REGARDING 301 Kingsway (Uno) Warranty Review

1956.00
301 Kingsway - Uno
20 December 2007

REGARDING Warranty Review

Photograph 1.3

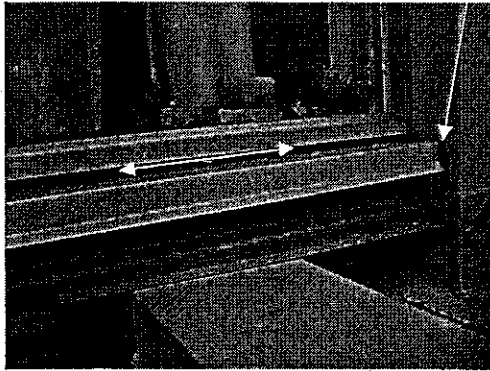
Observation: The window sill flashing installation is incomplete at bedroom of Unit 607. Flashing end-dams and sealant are not installed, allowing for direct water penetration behind the cladding. The flashing also appears to be cut too short for the window opening.

Action Required: Complete window flashing and sealant installation.

Photograph 1.5

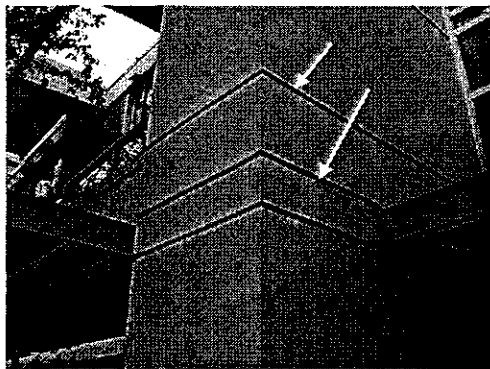
Observation: Sealant is missing from the second level slab cold joint reveals at the southwest corner of the city-homes building.

Action Required: Install bond breaker tape and sealant at the cold joint reveals.

Photograph 1.8

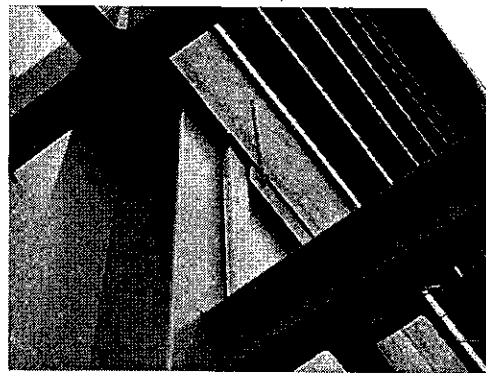
Observation: The glazing pressure-plate cover is loose above the ground level canopy at the northwest corner of the high-rise.

Action Required: Snap-in pressure-plate cover.

Photograph 1.9

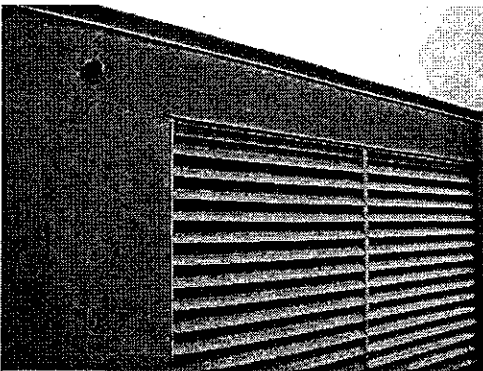
Observation: Sealant is missing from perimeter of the mechanical louver at the south end of the city-homes building (fifth floor at stairwell).

Action Required: Install backer-rod and sealant around perimeter of louver.

Photograph 1.17

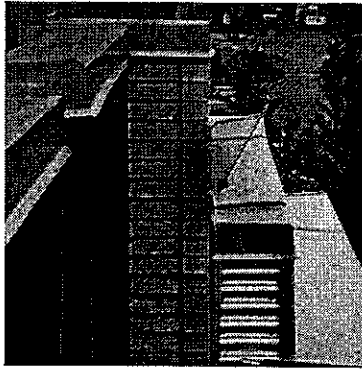
Observation: Sealant is missing from a brick-to-cap flashing joint at the northwest corner of the townhouse building.

Action Required: Provide sealant at brick-flashing interface.

Photograph 2.5

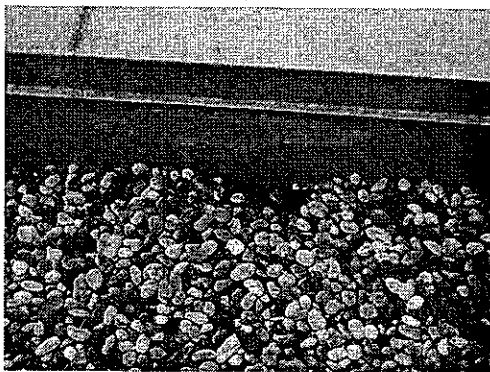
Observation: Gaps in the filter fabric and insulation occur at the perimeter of the roof area in several locations at the main and upper mechanical roof of the high-rise building. This has allowed ballast to fall down to the roof membrane.

Action Required: Remove gravel ballast from contact with roof membrane and install additional insulation and filter fabric at the perimeter of the roof where required.

Photograph 2.12

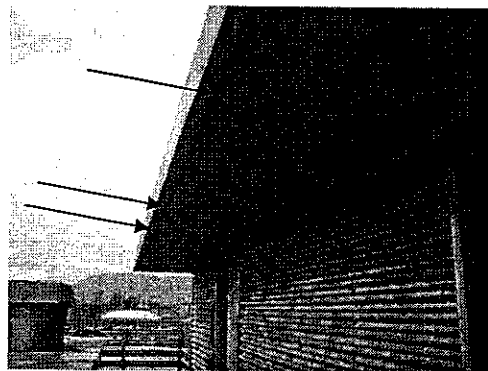
Observation: Several cracks within the concrete overhang at the rooftop mechanical room are allowing water leakage through the waterproofing membrane. The cracks are reflected through the top of the overhang through to the soffit.

Action Required: Apply fabric-reinforced polyurethane traffic coat over all exposed cracks at this location.

Photograph 2.13

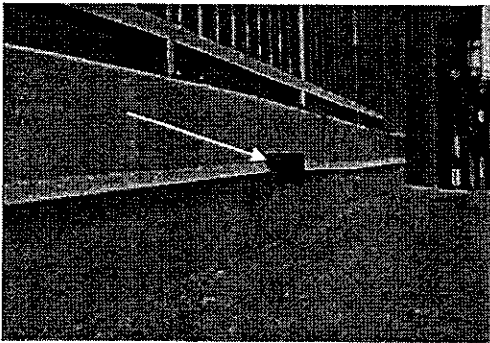
Observation: Sealant is missing around the perimeter of the scupper drain, north elevation of the high-rise at the balcony of Unit 318.

Action Required: Inspect all scupper drain locations and provide sealant where missing around perimeter of scupper drains.

Photograph 3.10

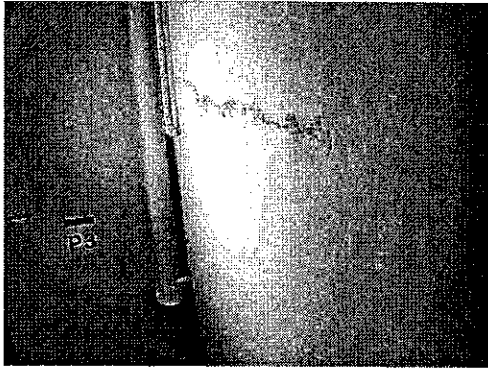
Observation: Ponding water observed within the parking garage (level P1) at the corner of the resident parking area entrance gate.

Action Required: Re-slope affected area as required.

Photograph 3.11

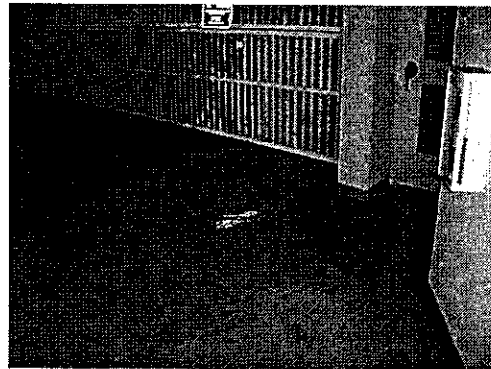
Observation: The top coat of the waterproofing traffic membrane adjacent to the trench drain at the parking garage entrance has debonded at several locations.

Action Required: Remove and re-apply polyurethane traffic coat at debonded areas.

Photograph 3.13

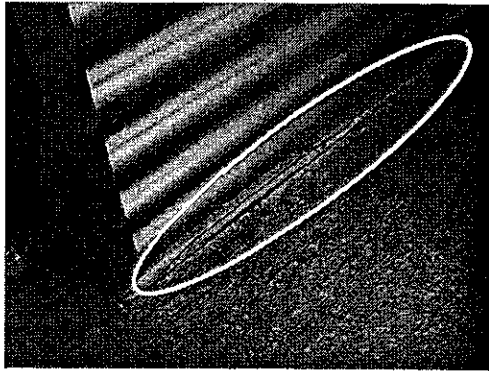
Observation: The base of wall flashing at the main entrance to Townhouse 390 is corroding.

Action Required: Replace corroded flashing with new metal flashing. Flashing should be isolated from the concrete.

Photograph 3.15

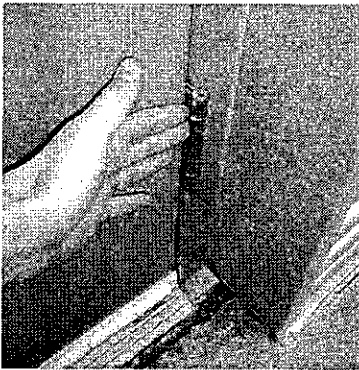
Observation: The bottom door hinge at the main entrance to Townhouse 390 is corroded.

Action Required: Replace affected hinges.

Photograph 4.3

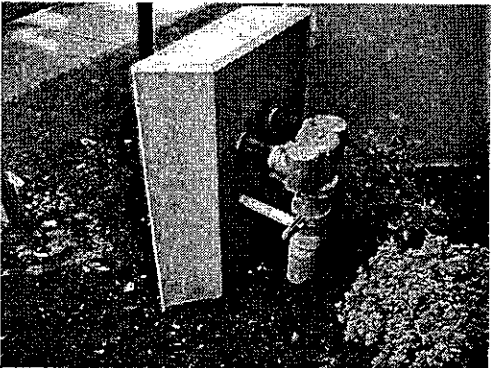
<p>Observation: The siamese fire connection pipes are unpainted.</p> <p>Action Required: Paint unpainted components.</p>
